INDEX 1965 - 1966

TECHNICAL SERVICE BULLETINS

SECTION D

Re: Gearbox Mounting

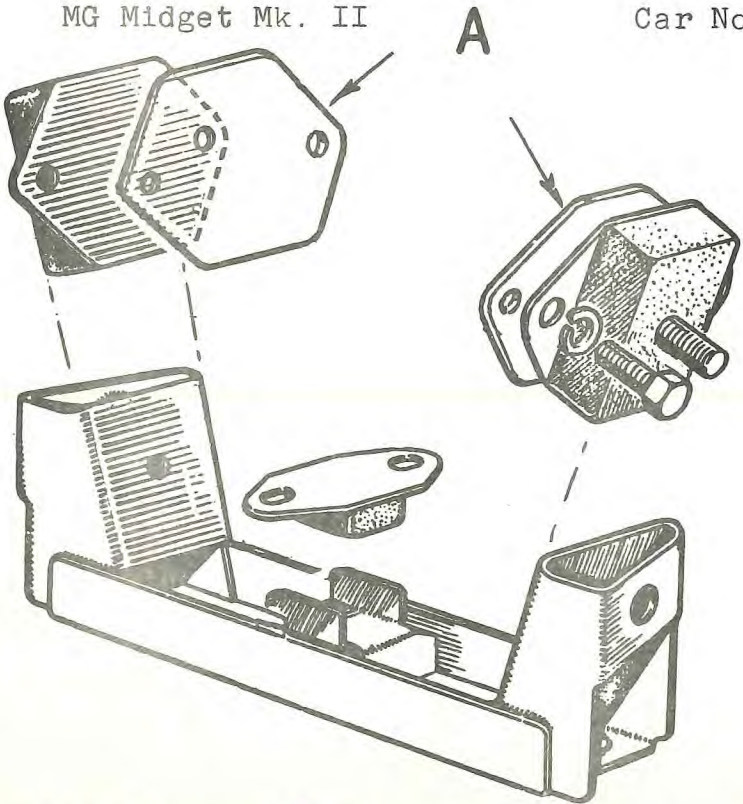
Certain complaints of engine vibration and harshness have been traced to the gearbox rear extension resting on the rear mounting support.

This condition may be rectified by inserting packing pieces, Part No. 2A 5423, between the mounting assembly and the gearbox rear extension, as incorporated in production from the following change-points:

Austin Healey Sprite Mk. III Car No. 48403

MG Midget Mk. II Car No. 35589
